PRELIMINARY PLAN

PINE CANYON CONDO - BUILDING 1

OWNER: PINE CANYON LODGE
PROJECT: PINE VALLEY CONDOMINIUMS
LOCATION: 3567 NORDIC VALLEY WAY, EDEN, UTAH 84310
© vanZeben Architecture. This drawing shall not be reproduced without consent of vanZeben Architecture, nor shall it be used for any project other than the originally intended project.

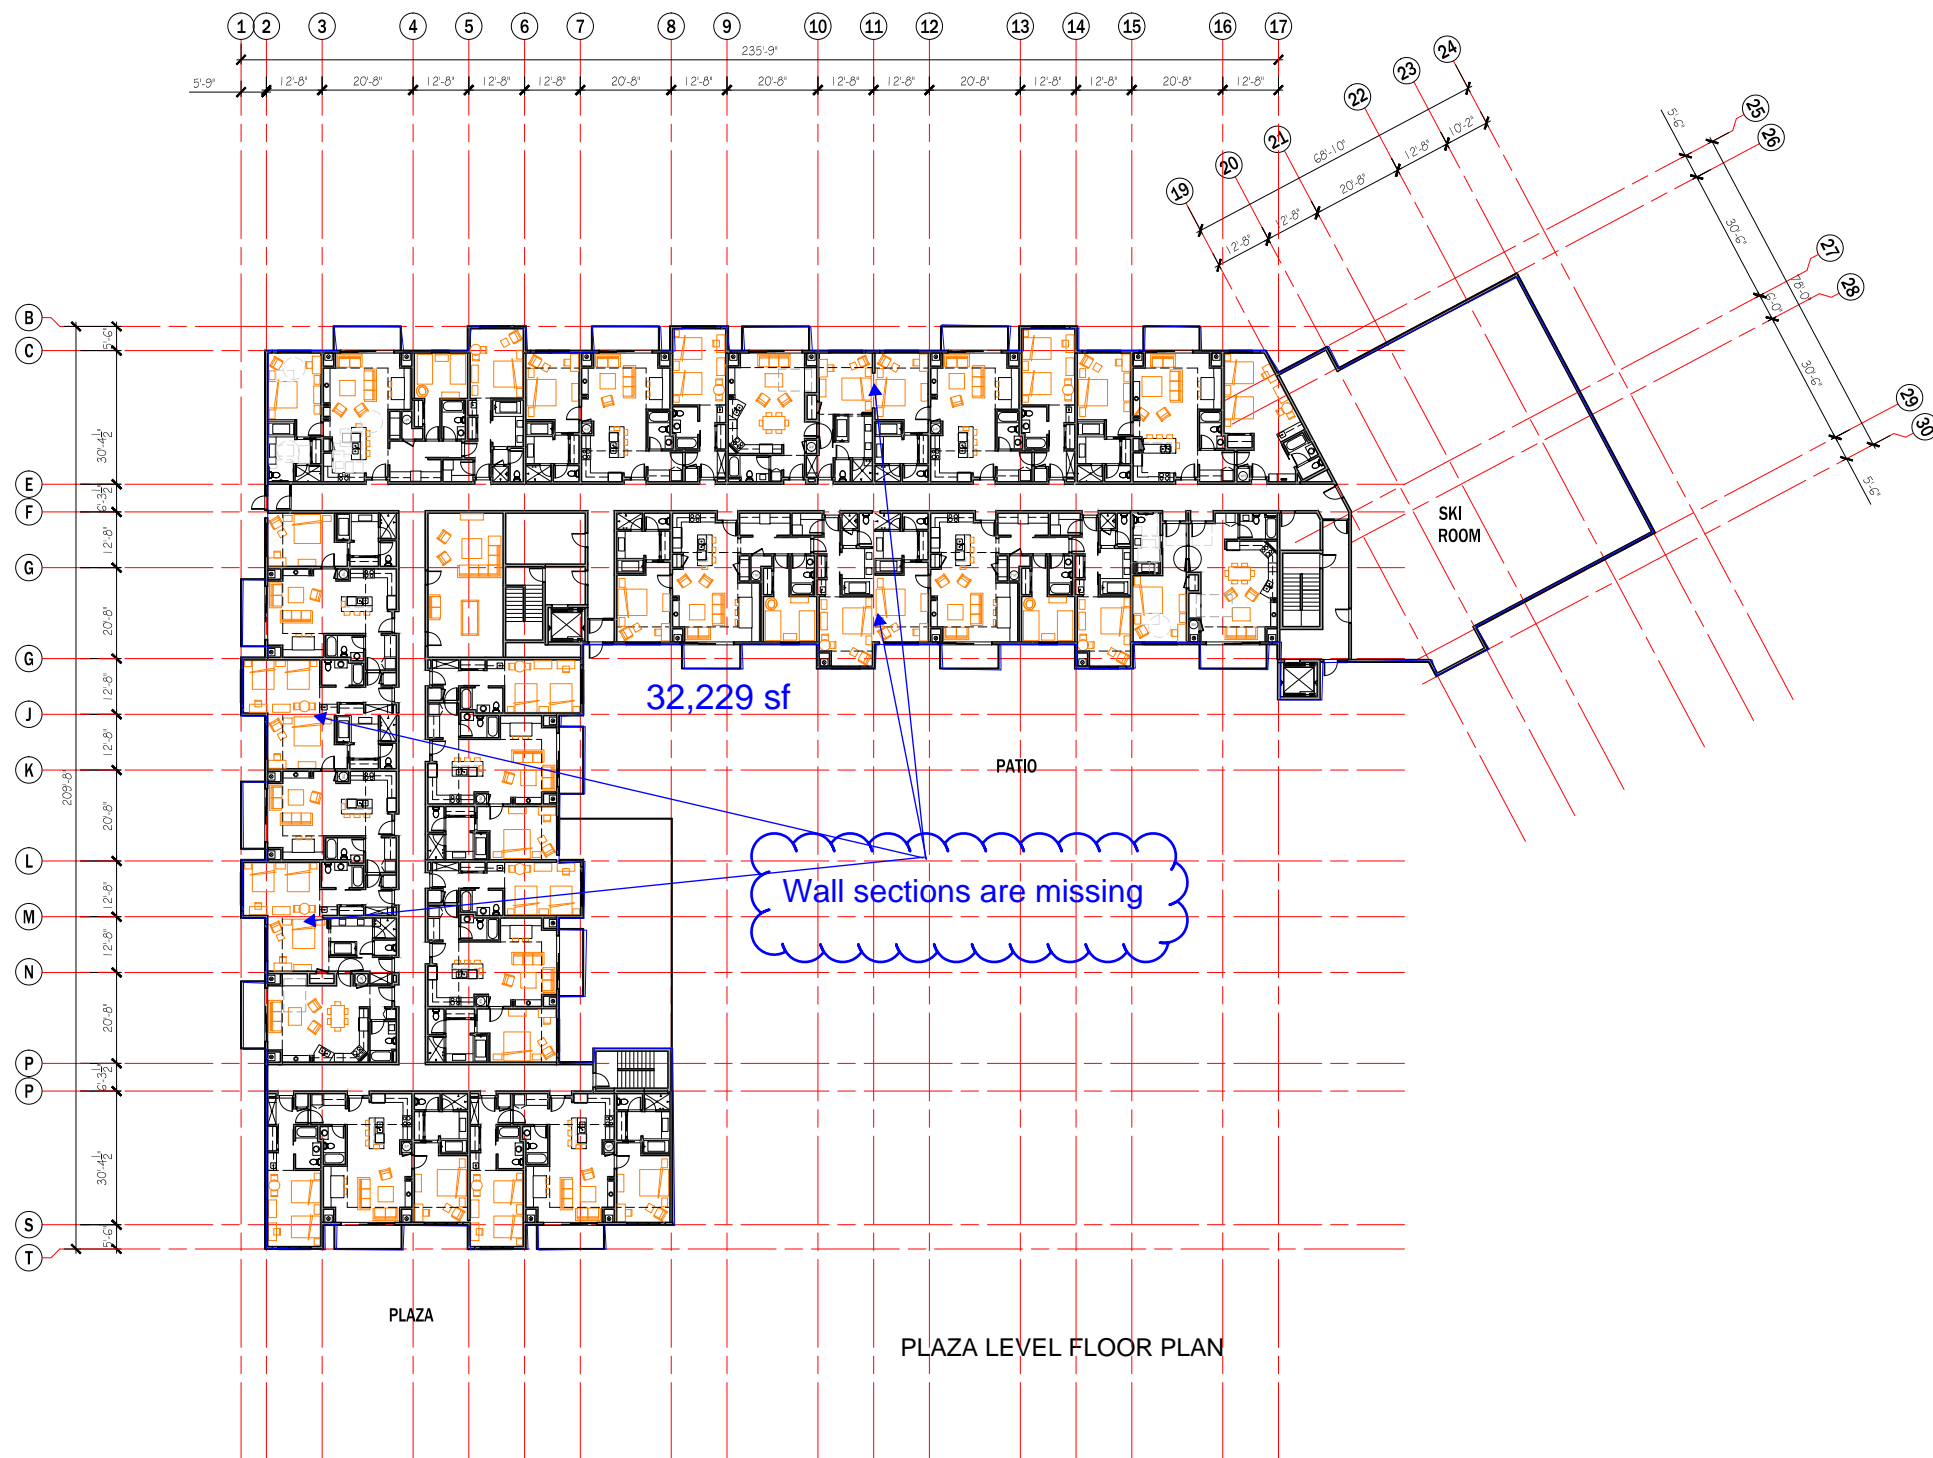
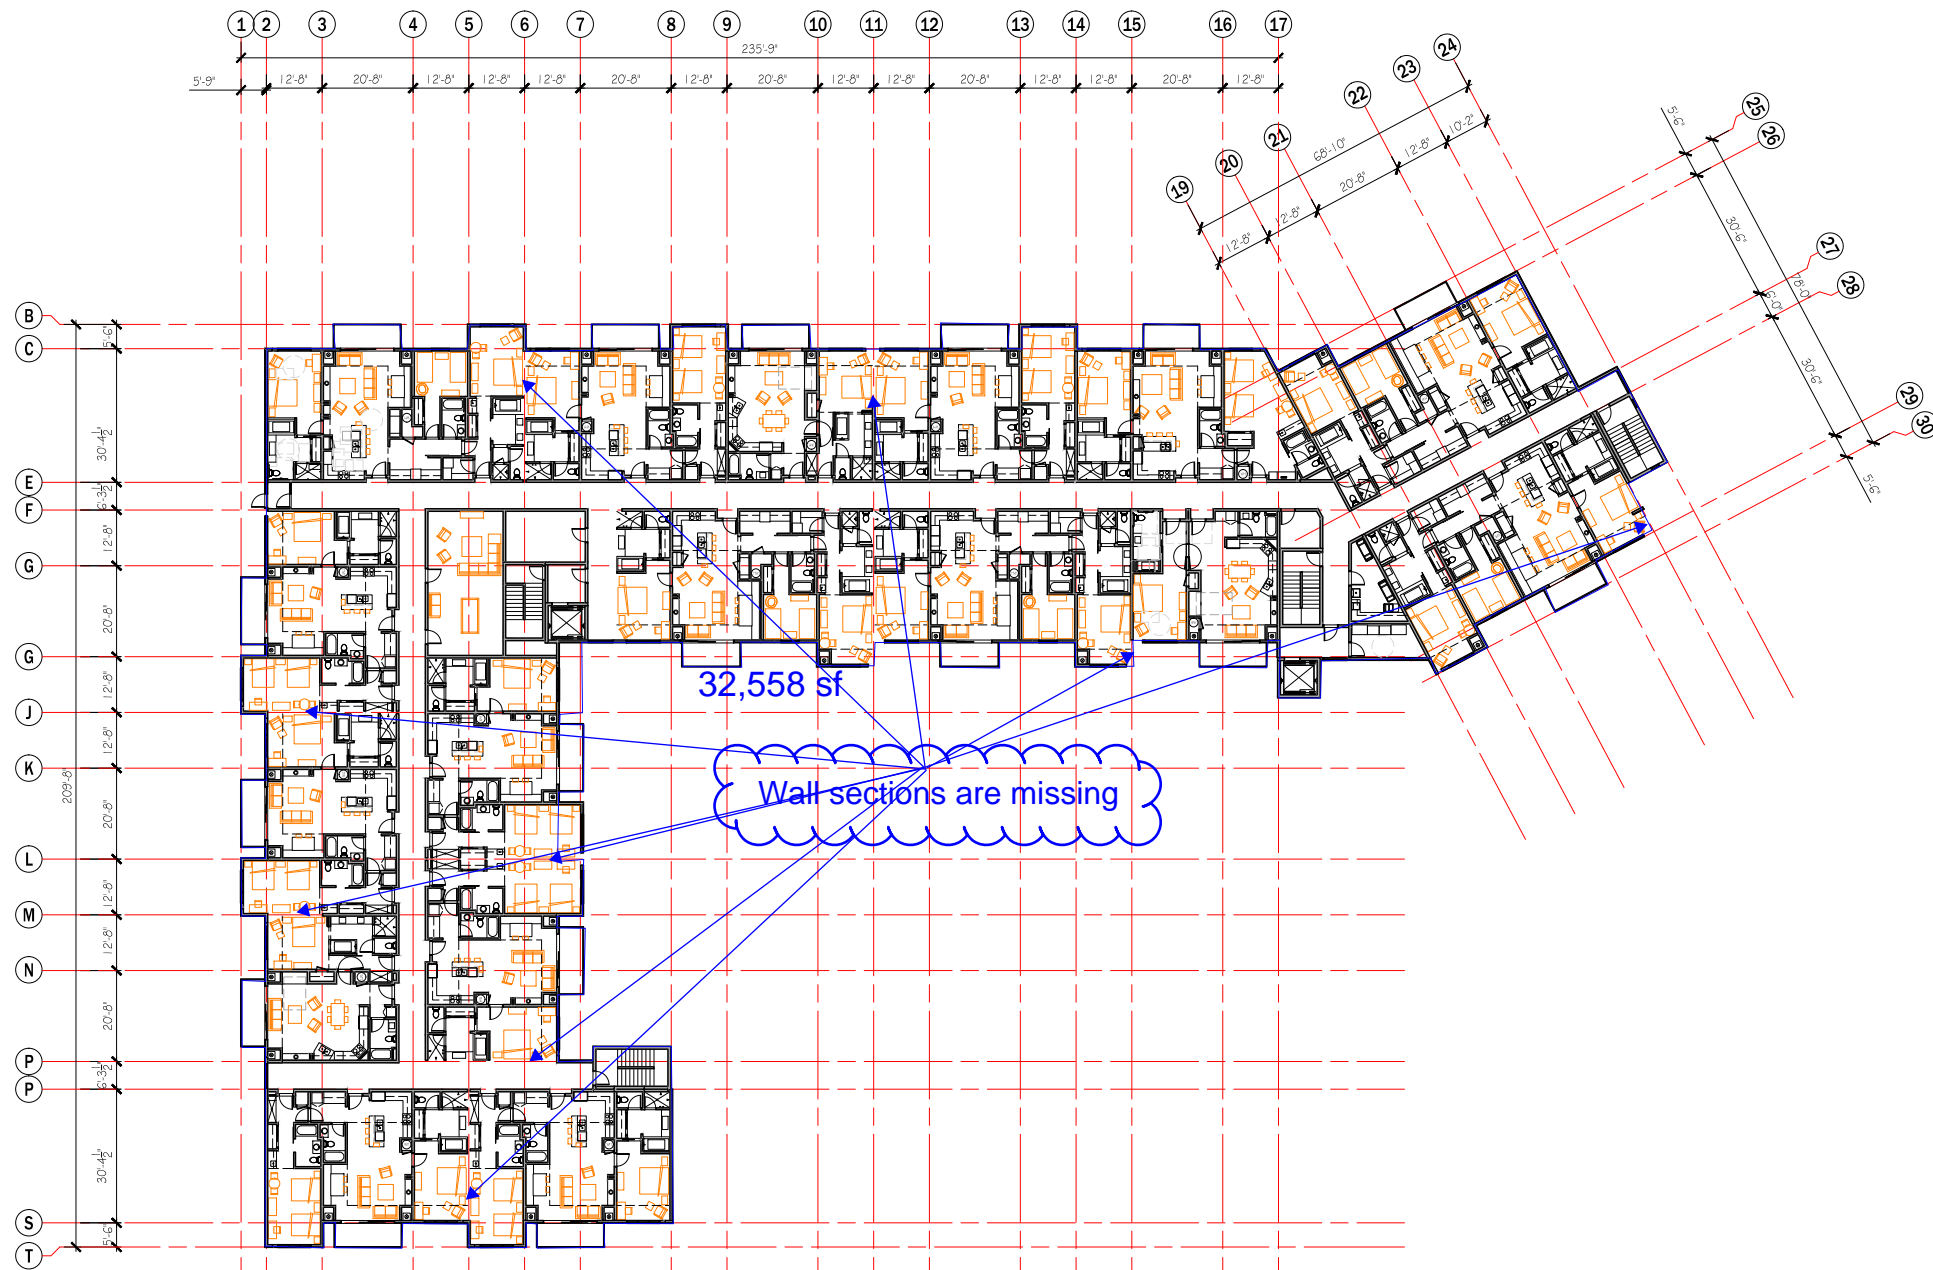
According to my measurements, the lower level floor plan/parking is approximately 30,806 sf. If my measurements are incorrect, please provide me with detailed measurements that I can verify. If my measurement is correct, please update the footprint area.

There is not commercial area on the 4th floor

According to my measurements there is only 9,645 sf allocated on the plans for commercial area. According to the revised plans 12,188 sf is required for commercial. Please revise.
